# **New Acland Coal Mine Stage 3 project**

## **Coordinator-General's change report No. 3 – amendment to stated conditions B3 and H40**

**September 2020**

Figure 2 – Air quality monitoring locations

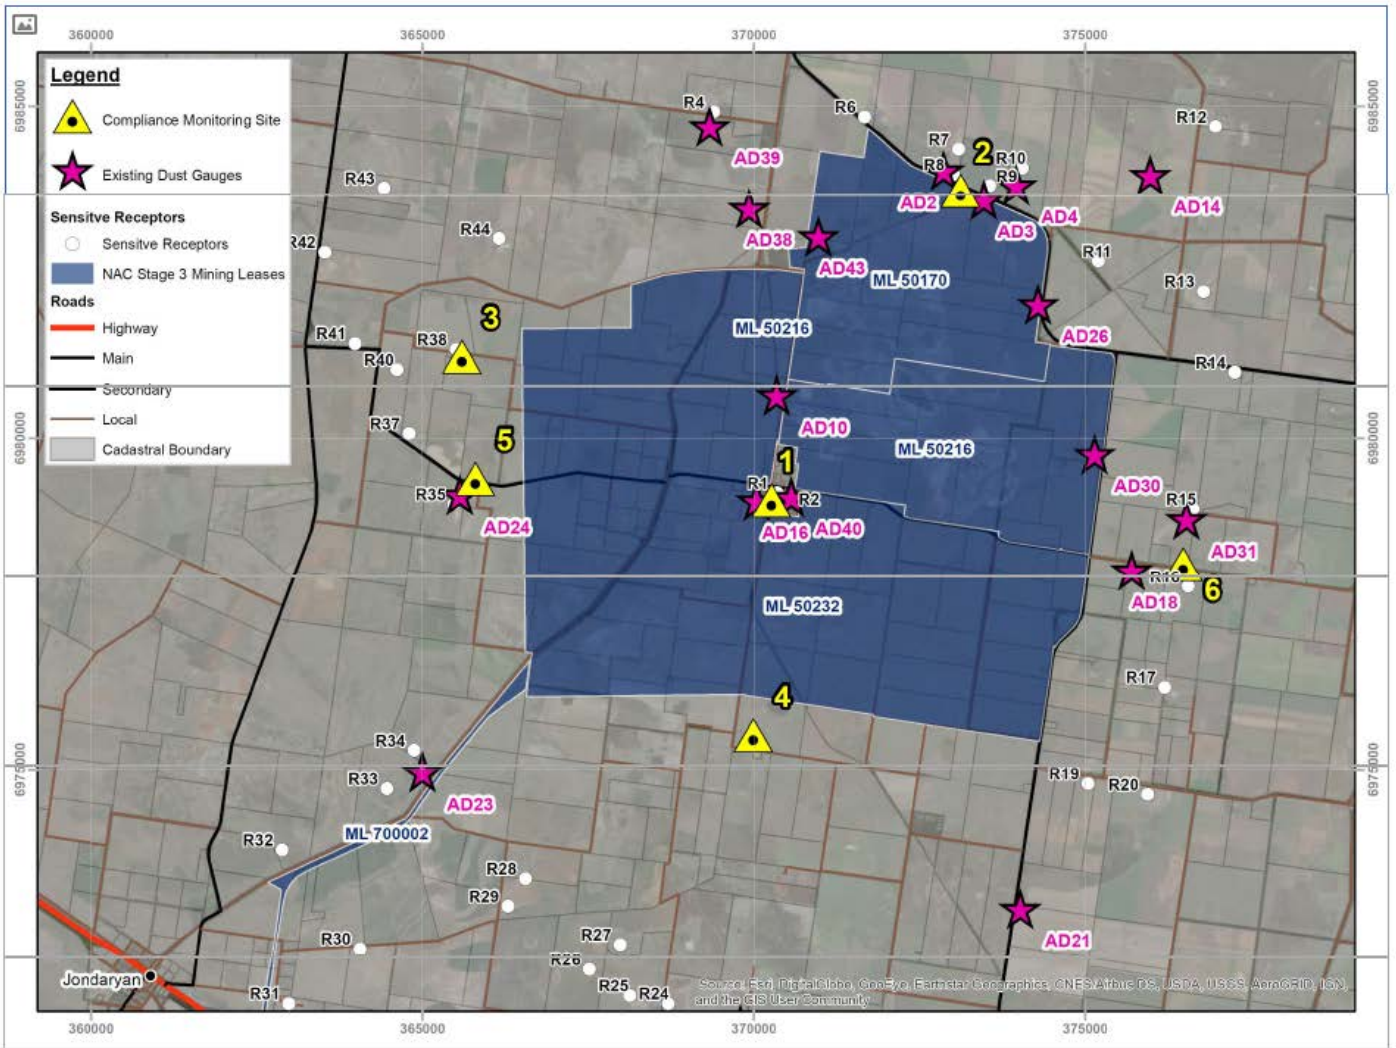
The change application seeks to update a figure referenced by Table A of stated condition B3 to align with the proponent's approved AEMP. The figure shows the location of air quality monitoring sites for the project. A change to the figure would have the effect of updating the proposed location of air quality monitoring locations for the stage 3 project to include additional continuous compliance monitoring sites for air quality.

The EIS proposed three sites for continuous monitoring; one in the township of Acland, one site to the east of the mine on Acland-Silverleigh Road and one to the west of Acland. The amendment to the condition would include three additional continuous monitoring sites: one to the north of the mine, one to the south of the mine, and an additional site to the northwest, between the mine site and residences.

The proposed amendment to stated condition B3 doubles the number of sites at which compliance with the air quality conditions of the project's environmental authority would be continuously monitored from three to six, consistent with the recommendation of the Land Court in relation to the number of sites to be monitored.

The additional compliance monitoring points are located to the north, northwest and south of the project which is consistent with the recommendations of the Land Court in relation to the location of these sites.

- removal of seven proposed dust deposition monitoring locations around the JRLF from the stage 3 project EA, and inclusion of those sites on the JRLF EA EPPR00814313, which is already regulated by DES.
- the removal of two proposed air quality monitoring locations located approximately 5.6 kilometres to the north-northwest of the existing New Acland Coal Mine.

Accordingly, I have updated stated condition B3 to include a new map, Figure 2 – Air Quality Monitoring Locations, which reflects the air quality monitoring program established by the 2020 AEMP.
